UNITED STATES PATENT AND TRADEMARK OFFICE

APPLICATION NO.	FILING DATE	FIRST NAMED INVENTOR	ATTORNEY DOCKET NO.	CONFIRMATION NO.
10/809,055	03/25/2004	Scott Lauffer	DC-06923	7005
33438	7590	05/04/2005	EXAMINER	
HAMILTON & TERRILE, LLP			PAPE, ZACHARY	
P.O. BOX 203518			ART UNIT	
AUSTIN, TX 78720			PAPER NUMBER	
			2835

Office Action Summary

DETAILED ACTION

Fig 1

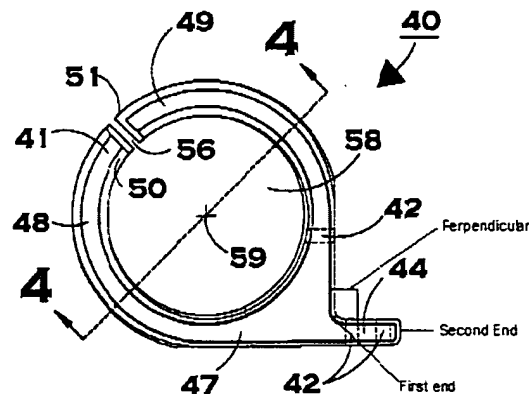
25. With respect to applicants arguments on claim 16 that the Cho et al. and Hathcock et al. fail to teach, disclose, or suggest a support arm fixed substantially perpendicular to a ring to couple to a stand with the ring in substantially parallel alignment, the examiner calls attention to present office action Fig 1 below detailing the 90 degree angle between the ring and the first end of the support arm.
